**Preservation Department – Item 2, LPC-23-04530**

## **21-26 45th Avenue – Hunters Point Historic District**

**RESPONSE TO LPC WARNING LETTER WL-23-0389**

LPC RE-SUBMISSION  
REV 5-24-23

**FRONT FAÇADE WINDOWS**  
Context – North Side

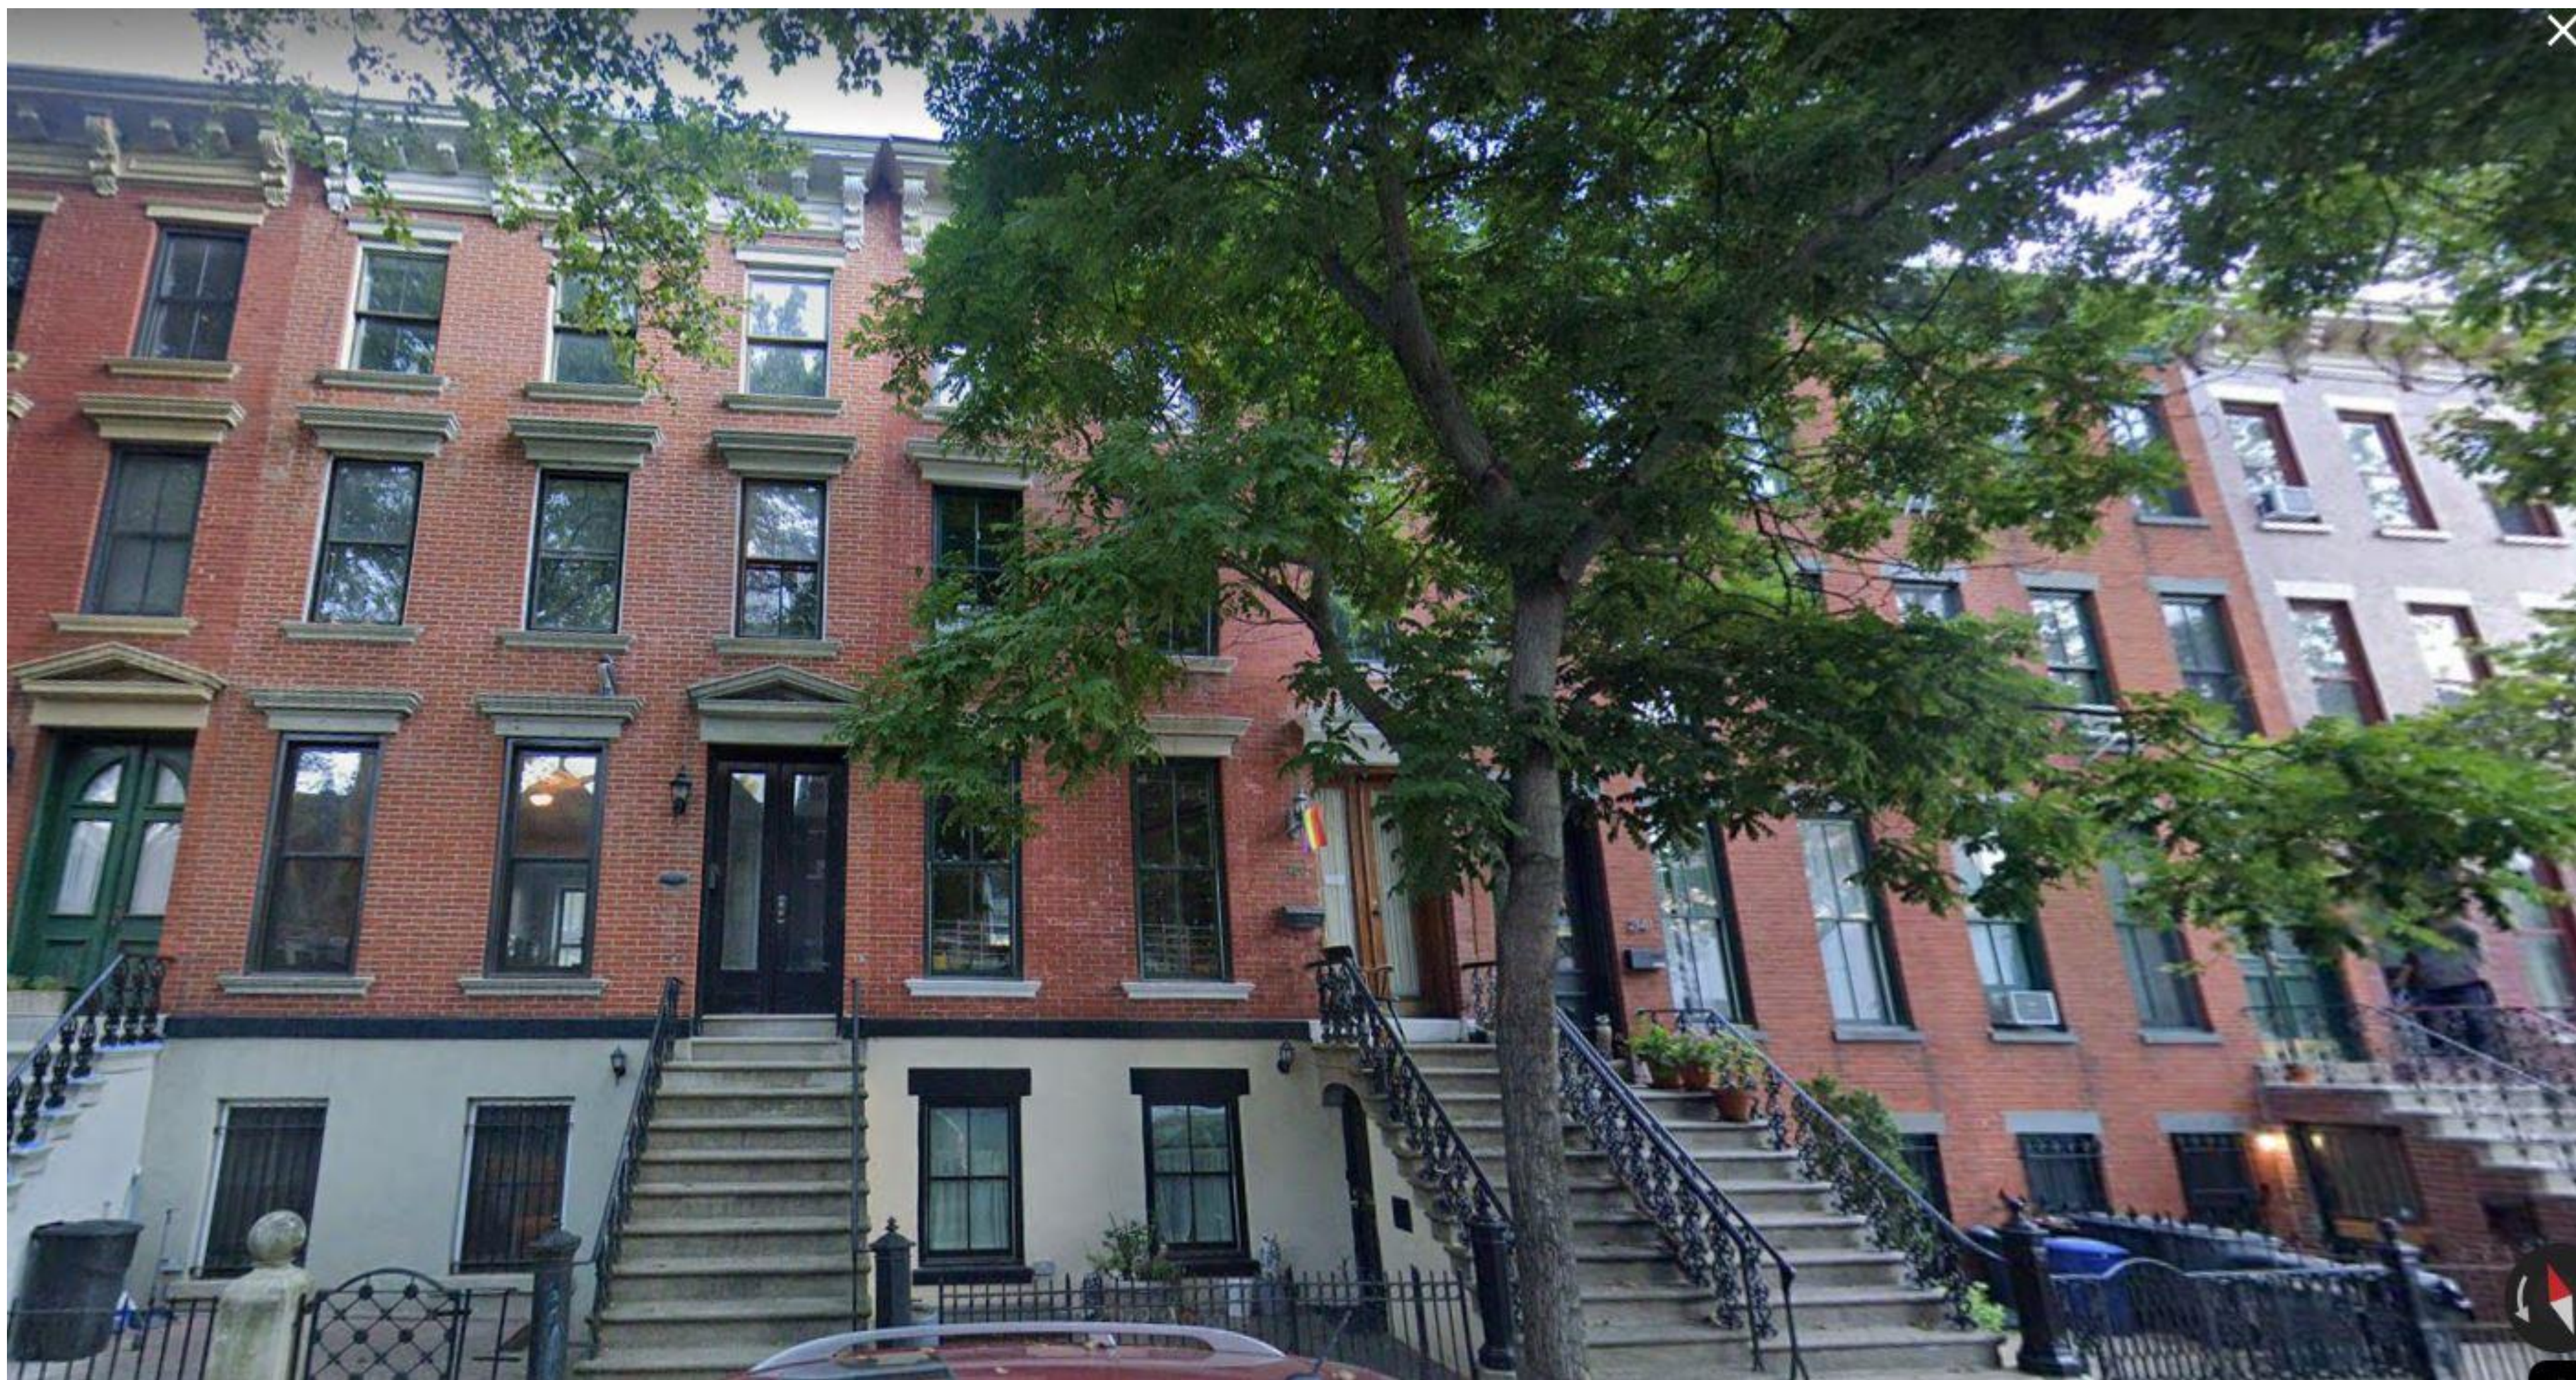
**LPC COMMENT TO BE ADDRESSED:** Replacement of windows in noncompliance with Certificate of Appropriateness 19-31915 issued November 28, 2018.

**OUR RESPONSE:** The photographs on this sheet show we are in substantial compliance with the Certificate of Appropriateness referenced above. The First and Second floor installed windows conform to the window type, function and color as per the Approved Drawings. The First and Second floor windows substantially align at the meeting style with the adjacent double hung windows (see red guideline) creating the desired impression of a continues façade of similar double hung windows in punched opening of a brick façade. The existing installation is in line with the A[[rpved drawings except for minor dimensions differences between the top and bottom sashes at the First and Second floor - any remedy would essentially result in a very similar visual outcome after a very substantial financial outlay by the owner. Also we feel that the installed widows do not detract from the perception of the façade as being part of a historical fabric. The panoramic photograph below of the entire row of historical houses on the street serves to illustrate this point

DETAIL FROM SHEET A201.00 OF THE LPC APPROVED SET

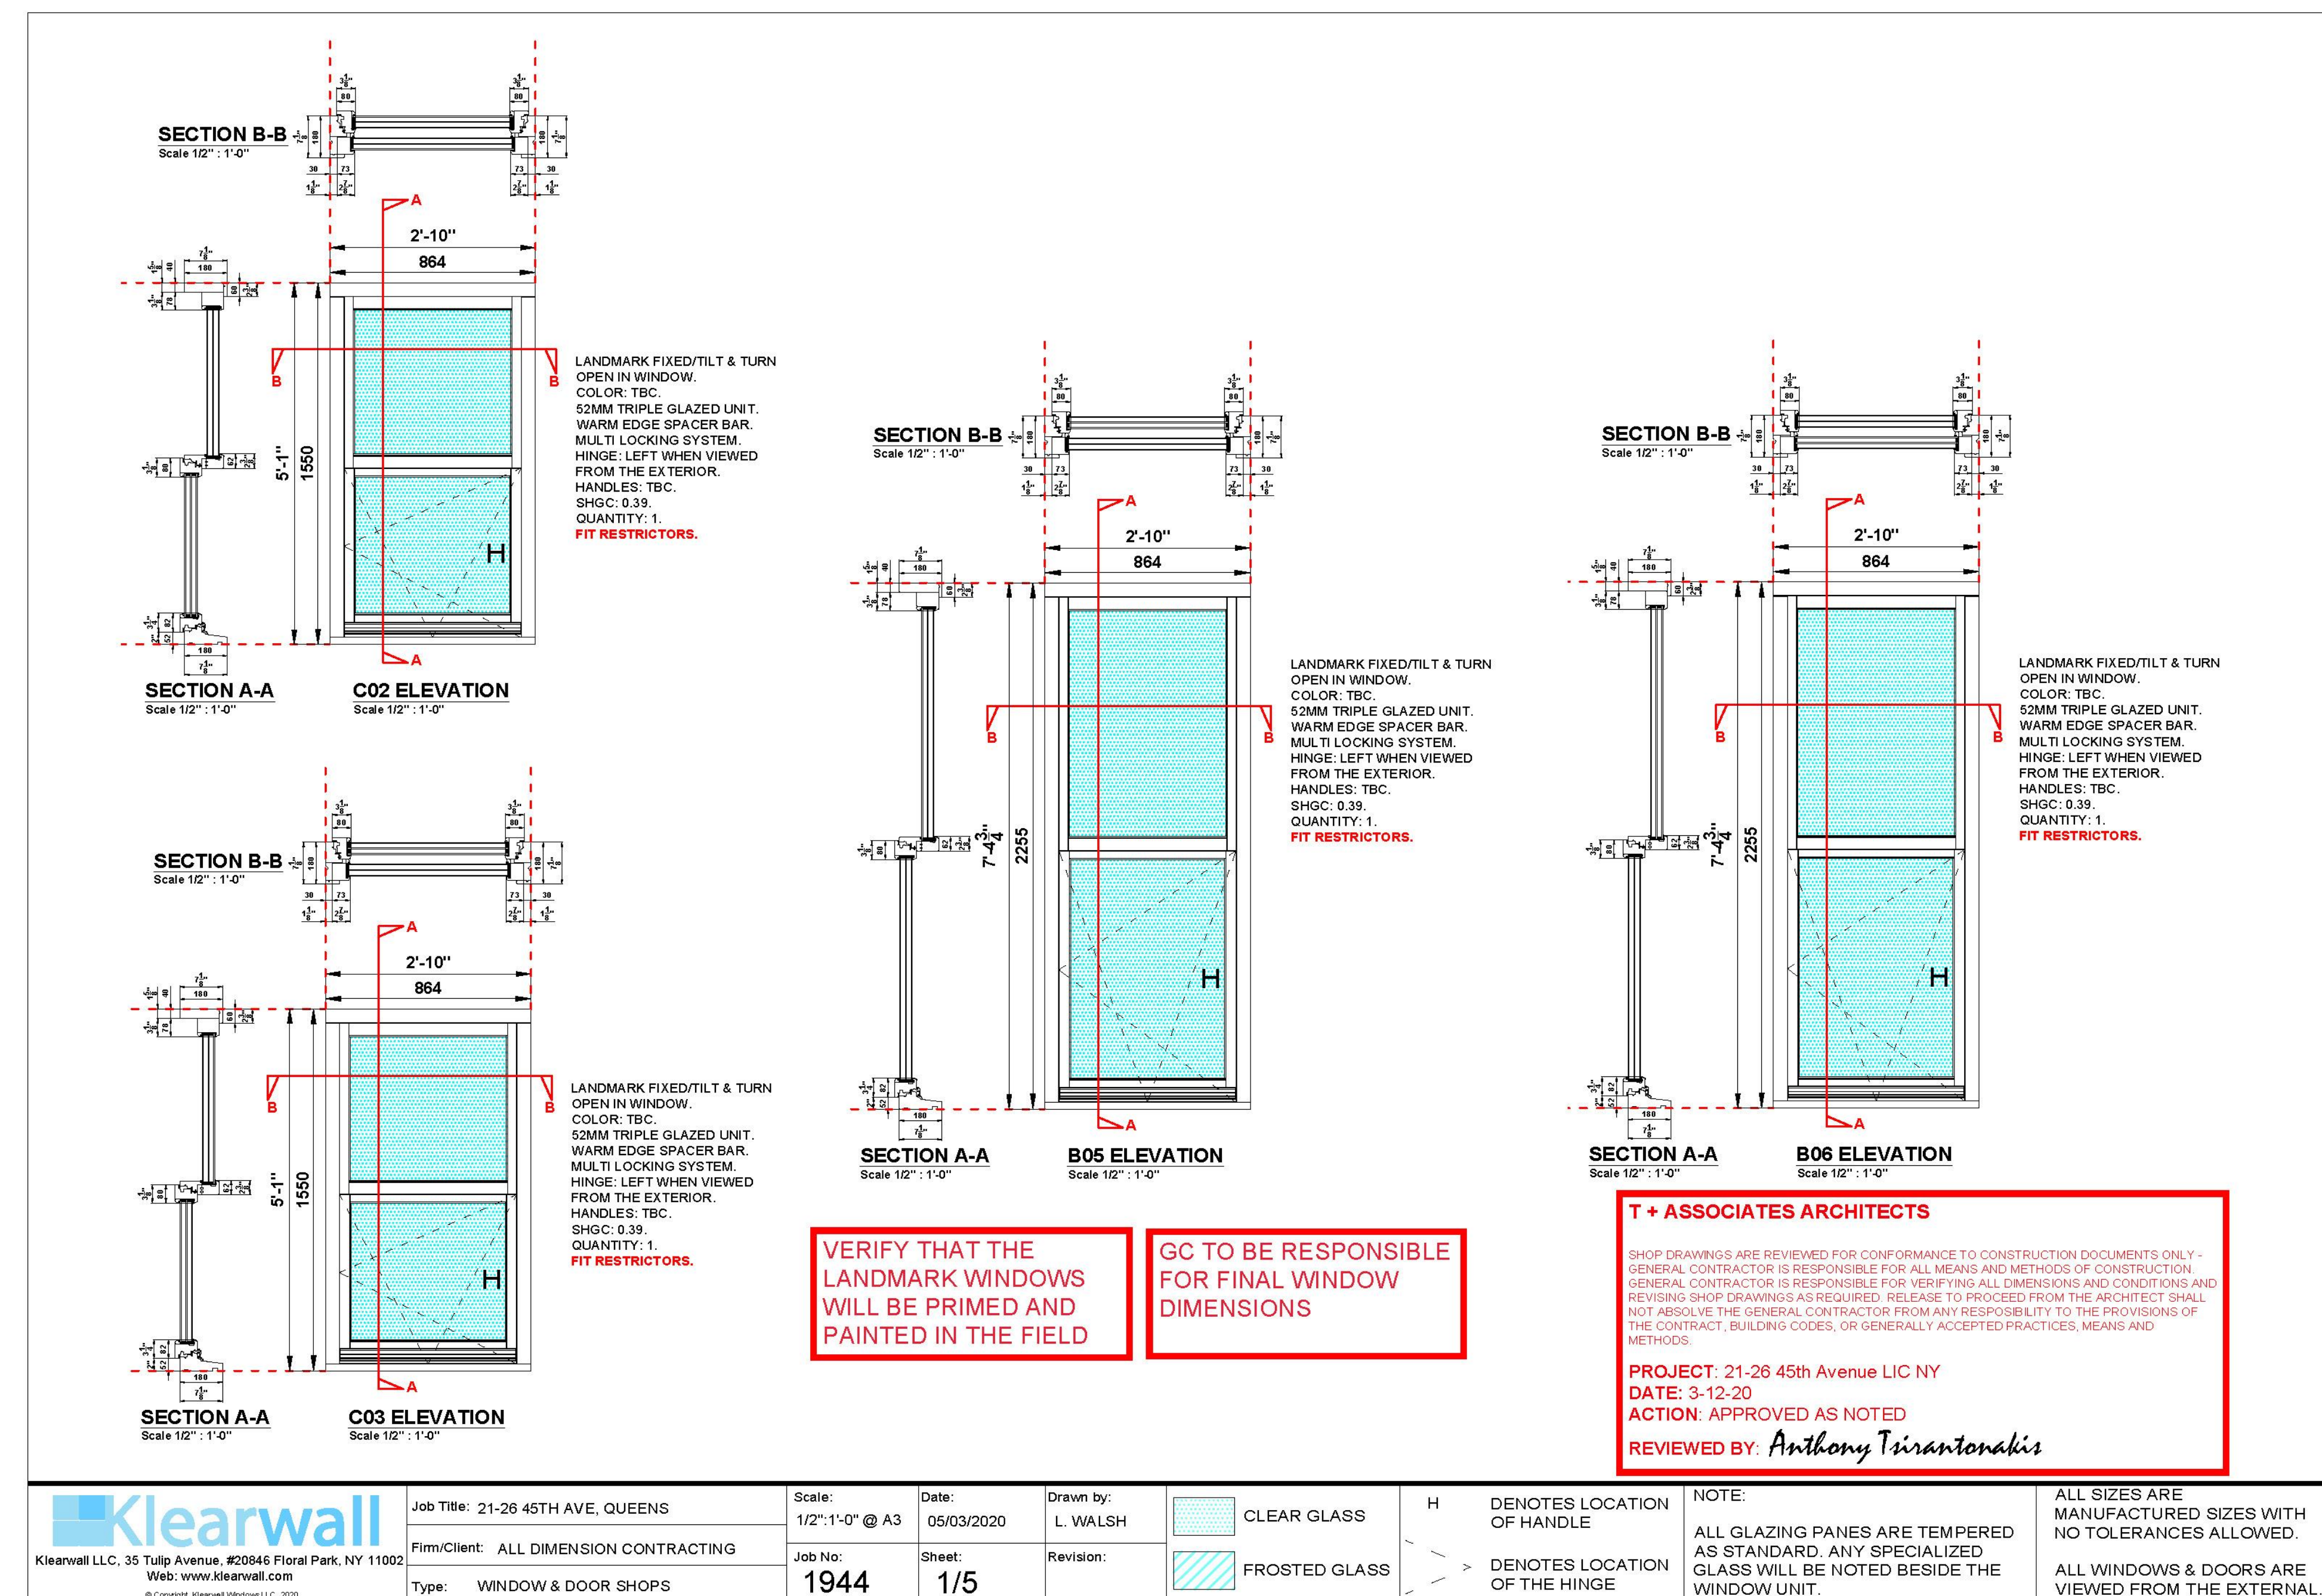
**LPC COMMENT TO BE ADDRESSED: Replacement of windows in noncompliance with Certificate of Appropriateness 19-31915 issued November 28, 2018.**

The LPC originally approved windows at the front façade that had a 2" sash and a 1-1/2" frame for a total of 3-1/2" on the exterior. The approved manufacturer was Klearwall and they were triple-glazed passive wall windows. What was installed was per the design drawings with minor dimensional changes - the shop drawings which reflect the installed windows show a sash of 2-7/8" with a visible part that is 1-1/8" (the actual visible part is 1-1/16") with a frame of 3-1/8" – on top of the frame is a brickmold of 1-1/16" (the actual brickmold is 1-9/16"). The total dimension on the approved design drawings for all the elements is 3-1/2" – what was installed totals 4-1/8". The windows that were installed are the one specified on the approved drawings in terms of color, pattern and nominal size. As you well know window types and schedules on CD plans are for design intent and the product sizes are nominal - the finished product dimensions are always a little different even when they are matching the specification. I would say that these windows fulfill the design intent of the original submission - the dimension changes do not instrumentally change the original intention of the design or detract from the perception of the façade as being part of a historical fabric.
